TransTechnical Bulletin

TB18 7/99

Application: Mazda F4A-EL

Subject: Accumulator O-ring and D-ring Changes

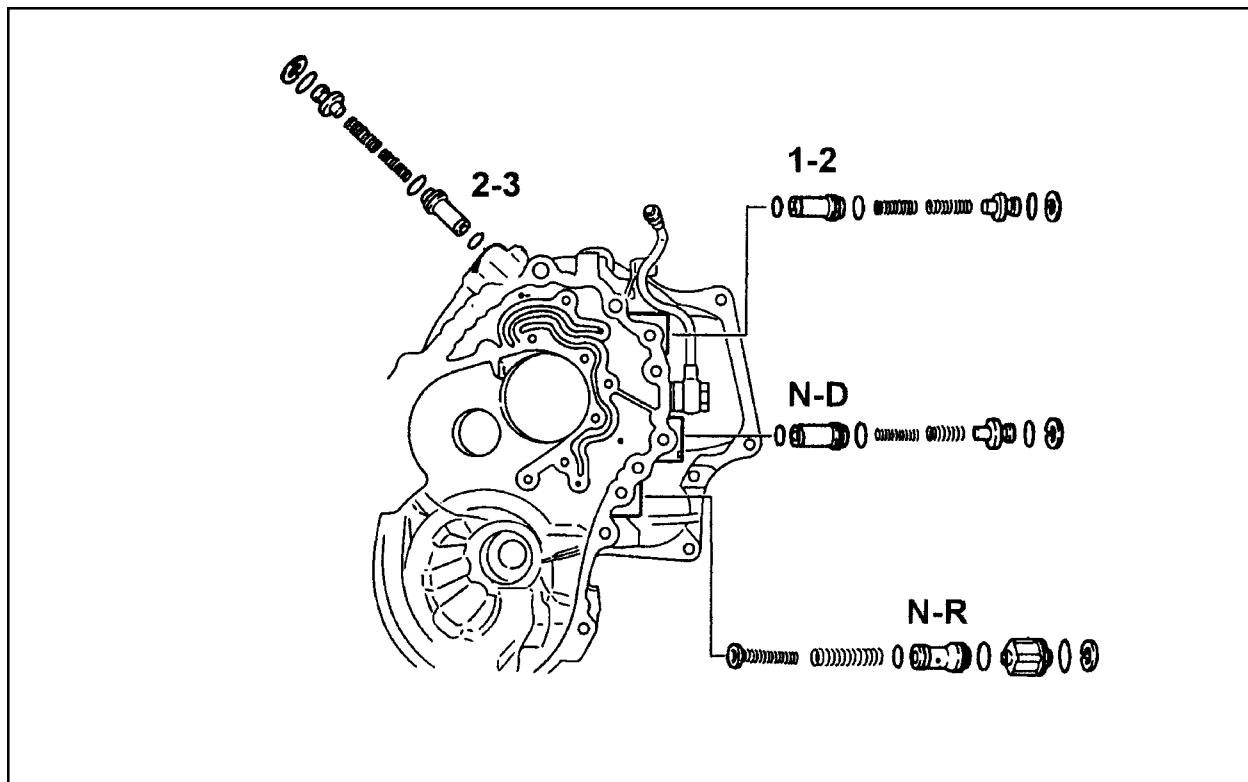
We will now be offering a more durable, Viton material O-ring and D-rings for the F4A-EL accumulator pistons.

TransTec P/N	Type	Position
17810	O-ring	N-D Accumulator
26535	D-ring, large	1-2, 2-3, N-D, and N-R Accumulators
26525	D-ring, small	1-2, 2-3, and N-D Accumulators

All TransTec overhaul kits with date code **G99** and later will contain the new O-ring and D-rings in their appropriate sub-packs.
